Review of 2024 Vedder River Gravel Removal Plan

April 18, 2024
Final Report, Rev. 0

NHC Reference 3008518

**BC Ministry of Environment and Climate Change
Strategy**
Environmental Protection Division,
Victoria, BC

Figure 4.1 Comparison of baseline freeboard conditions from 2023 to 2024 flood profiles.

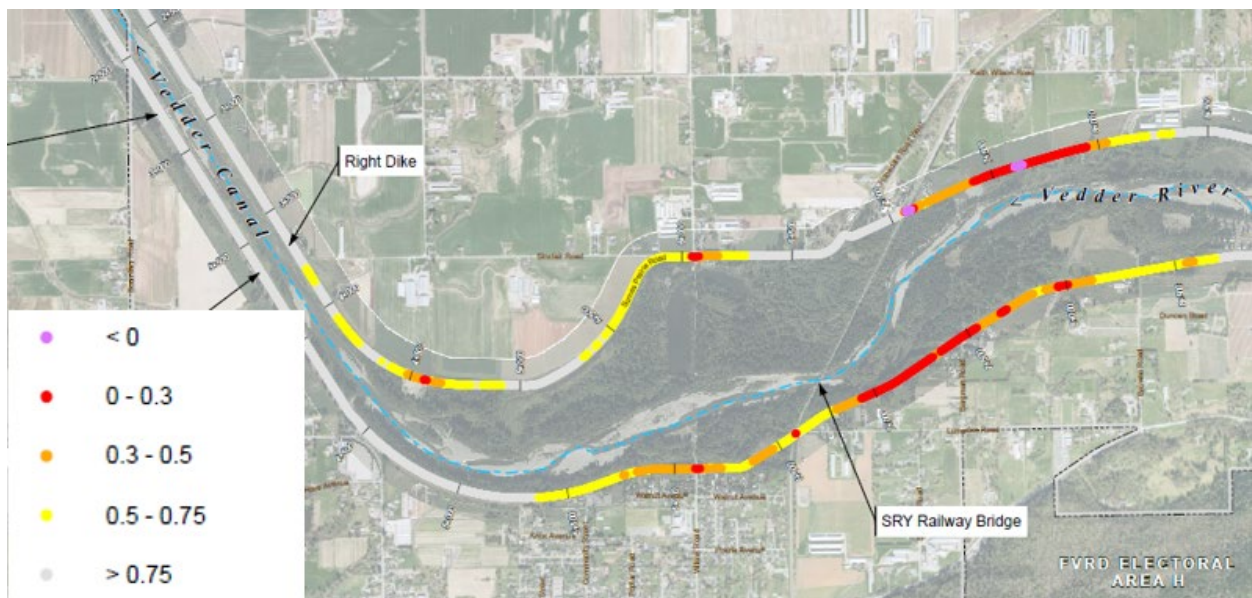
The updated flood profile in KWL (2024) produced substantially higher water levels along the Vedder River in comparison to flood levels reported in KWL (2022) and KWL (2023). The differences are illustrated by comparing the KWL (2023) (top) and KWL (2024) (bottom) freeboard deficient areas in Figure 4.1². KWL (2023) reported that the minimum freeboard was between 0.50 m and 0.67 m along the right dike and between 0.43 m and 0.57 m along the left dike. The freeboard deficiency varied from 0.08 m to 0.25 m along the right dike and 0.18 m to 0.32 m along the left dike. It was also stated that the freeboard prior to the 2021 flood was greater than 0.70 m at all sections.

The updated 2024 flood profile in KWL (2024) shows long sections of the dikes on both sides where the freeboard is less than 0.3 m and two locations on the right bank with freeboard less than 0 m (shaded purple). Although the most serious deficiencies occur upstream of the SRBC railway bridge, there are four locations downstream with freeboard less than 0.3 m.

² Note that the values shown on the top map from KWL (2023) are freeboard deficiencies while the legend on the bottom map shows absolute freeboard values.

Figure 4.2 Water surface profiles near railway bridge from three hydraulic model runs showing the effect of sediment deposition from the 2021 flood event (2022 versus 2020) and the effect of model calibration (2024 and 2022). All results from KWL (2020), KWL (2022) and KWL (2024).

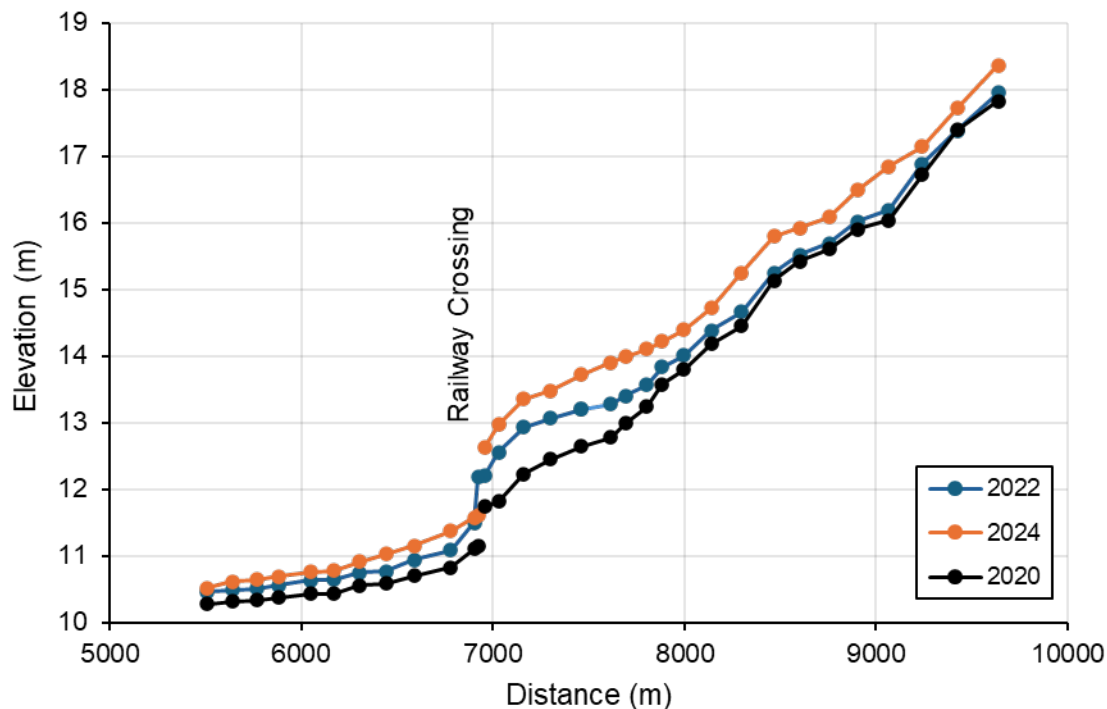
Figure 4.2 compares the computed flood levels from 2020, 2022 and 2024 to illustrate the sensitivity of the water levels to differences in bed topography (2022 and 2020) and model calibration (2024 and 2022). The flood profiles rise nearly 2 m through the SRBC railway bridge due to the severe constriction and backwater from the bridge. The comparison shows that the reported reduction in freeboard along

the dikes is due to changes (i) sediment deposition from the 2021 flood as well as (ii) changes due to the revised hydraulic model.

Figure 4.2 shows that water levels are sensitive to the local constriction at the bridge. At present, all models assume 200 m³/s of flow leaves the main channel on the right bank upstream of the bridge and passes through the relief channel and culvert at the railway embankment. They also assume 150 m³/s of flow leaves the main channel on the left bank and flows through the trestle at the rail embankment. These assumptions are based on an analysis from Bland (2008). Actual flow splits could be very different, particularly if debris and log jams occur (as in the November 1990 flood). Given these uncertainties, it is not unreasonable to assume that the predicted flood levels could be within ± 0.5 m of actual levels during a design flood event in this reach. This alone justifies the need for attempting to maintain at least 0.75 m of freeboard at all times.

Figure 4.3 Comparison of 2021 sediment deposition and Option D removals by reach.

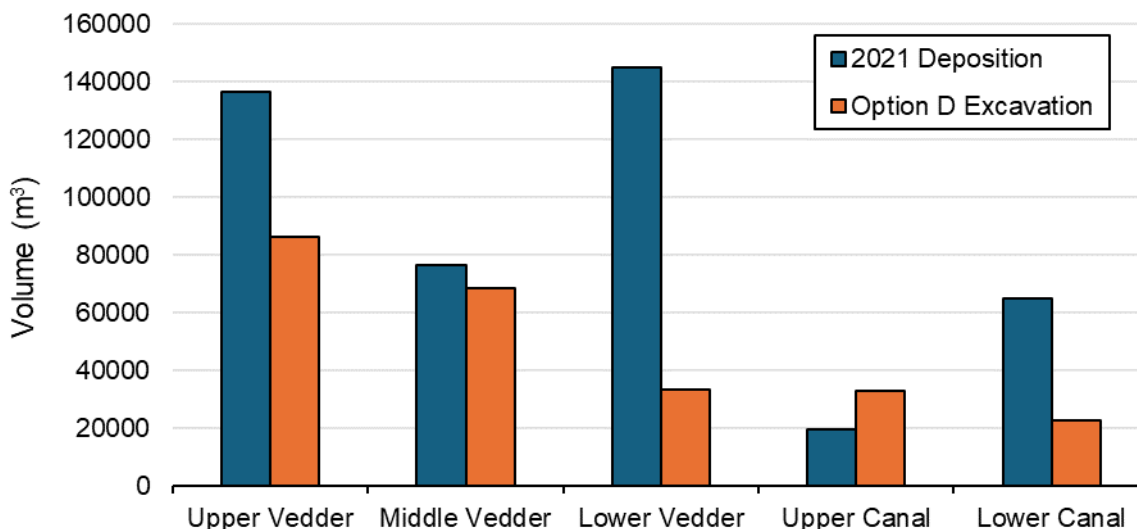
Figure 3.2 shows the location of the 11 sediment removal sites in KWL's (2024) recommended Option D. Figure 4.3 compares the removals with the 2021 deposition volumes. The three sites in the upper reach (S45, Giesbrecht, Peach) total 86,100 m³ and make up 35% of the total excavated volume. All of these sites are located upstream of the freeboard deficit reach. We assume these excavations will function as sediment traps to reduce the rate of infilling in the middle and lower reaches, but it is difficult to assess

how efficient the traps will be without additional analysis and monitoring. The remaining excavations should increase the flow conveyance in the freeboard deficit reach to varying degrees until they re-fill with sediment.

Figure 4.4 Comparison of recommended project (Option D) with no excavation (Option A).

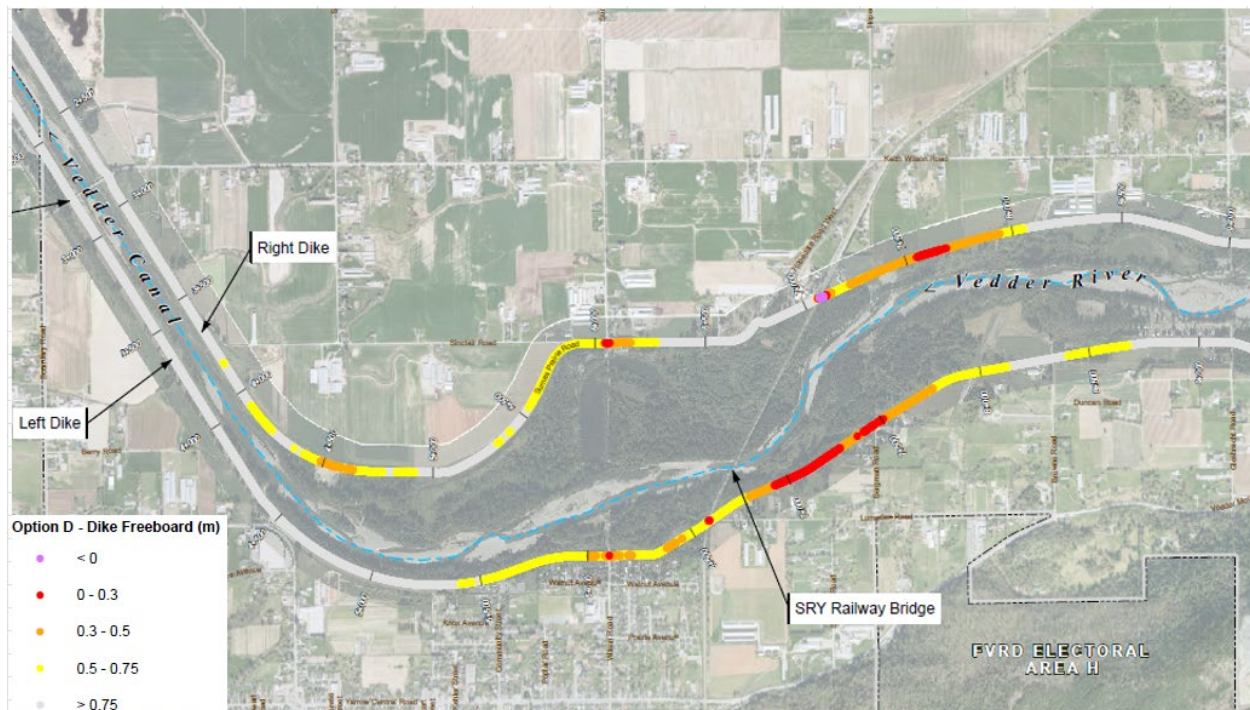
Figure 4.4 compares the freeboard conditions along the dike without any sediment removal (top) and after 248,500 m³ of sediment is removed (bottom). Although there is an incremental improvement to the freeboard, other additional measures are still necessary to improve the security against overtopping or breaching. The feasibility of installing temporary flood protection measures (Hesco flood barriers or “Super Sacks”) should be assessed as interim measures while other longer-term solutions are implemented. If additional structural measures (dike raising, floodway improvement) are not carried out then presumably another large removal will be required in 2026.

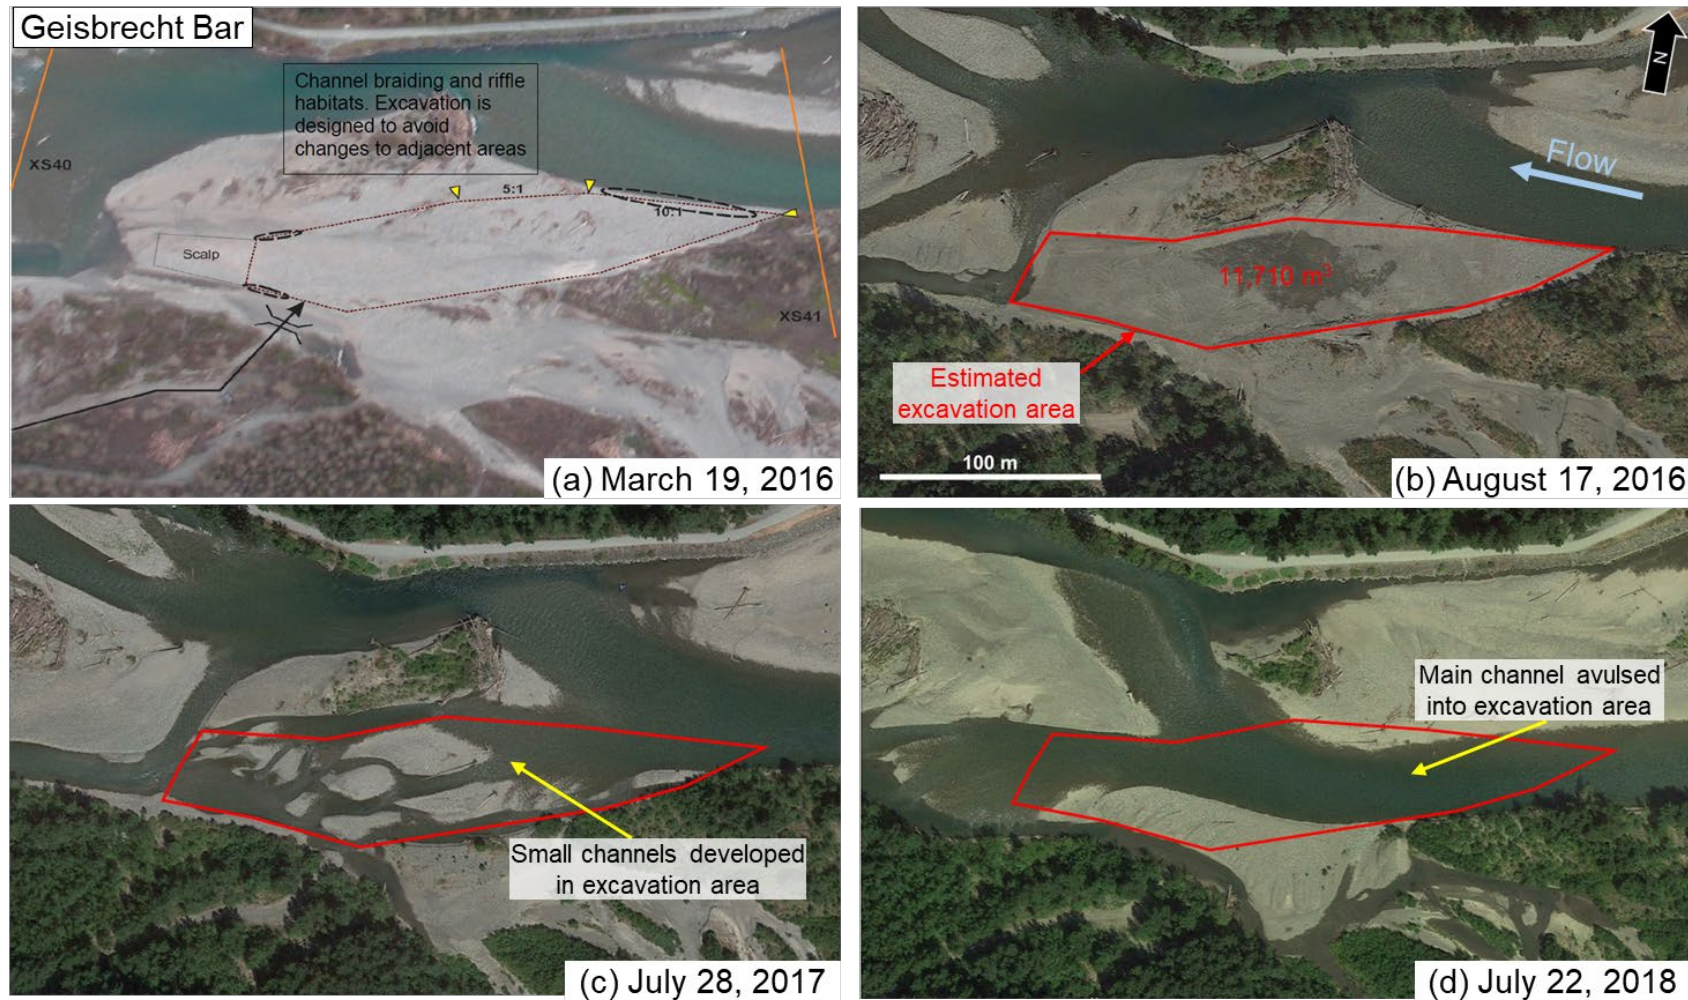
The bar-scale morphological response varied at the 2016 sediment removal sites, but in all the cases the impact of the excavation area was visible in the latter half of the 2017 freshet (July 2017) (Appendix A). The 2016 removal at Giesbrecht bar appears to be responsible for some substantial morphological change. An avulsion occurred between August 2016 and July 2018, as the main channel shifted its position and occupied the area of sediment removal (Figure 5.2).

These images illustrate how the bars and channel have responded to excavations during a period of low floods and low sediment inflows. During larger floods the channel changes will occur more rapidly with increased sediment transport. If the excavations fill relatively quickly, their effect on the flood profile will be less than the “fixed bed” hydraulic models indicate.

In the event Option D is implemented in the summer of 2024 then NHC recommends systematic, multi-year monitoring be carried out using available imagery and drone coverage to assess the morphologic response from the excavations. This should be combined with geomorphic field studies and local topographic surveys to document how bed elevations and morphology change at a reach scale and how bars downstream or upstream of the removal sites are impacted. Bed material samples should be collected at each excavation site during the first one or two years of infilling to document the sizes of sediments that are re-filling the excavations. In our opinion, systematic morphological monitoring of effects of the gravel removals has not been undertaken to the detail required to is forecast possible changes to the channel bed, sections and overall planform on a local and reach-wide basis. A geomorphic-focused assessment would provide a much stronger basis for determining:
